**STATE OF ALASKA
DEPARTMENT OF TRANSPORTATION
AND PUBLIC FACILITIES
SOUTHCOAST REGION**

Project No.: AIP 3-02-0111-007-2020 / Z675170000

Directive No.: 4

Project Name: GST AP Apron, Runway, and Taxiway Pvmnt Rehab

GST AIRPORT APRON, RUNWAY, AND TAXIWAY PAVEMENT REHAB.
 PLAN VIEW - RUNWAY 11/29

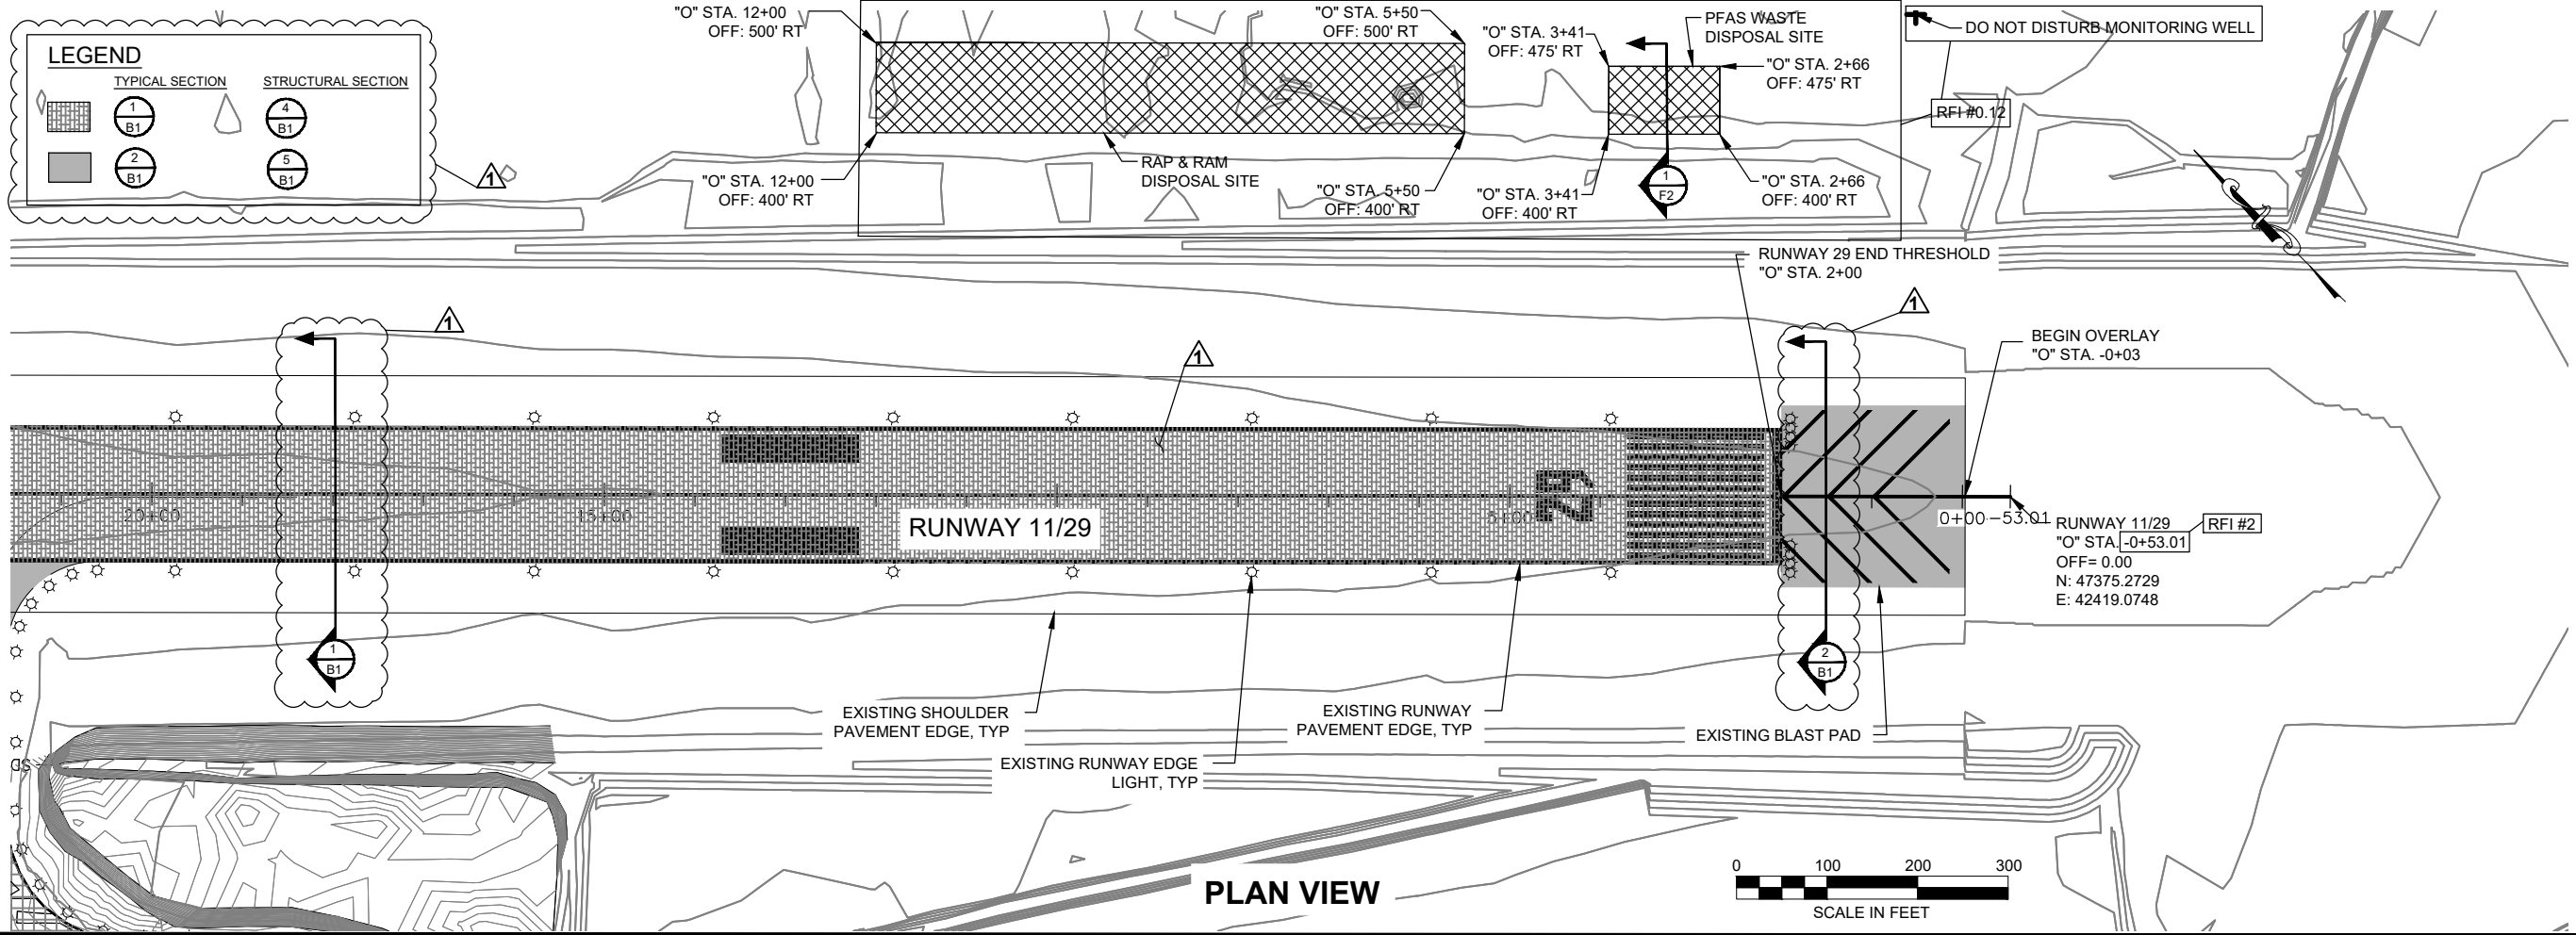
- a) The attached F2 revised plansheet, dated 3-15-21, showing the approved location for the stockpiling of excess RAP materials, will replace the Contract Sheet F2 by Change Order.
- b) Waste or excess RAP materials shall not be stockpiled, placed, or disposed of at the Department provided sites identified on Contract Sheet A7.
- c) Contract Specification P-401-3.4 Recycled Asphalt Pavement, which allows for the use of up to 10% of RAP in the hot mix asphalt mix design for shoulder or intermediate courses, will be deleted in its' entirety by Change Order.
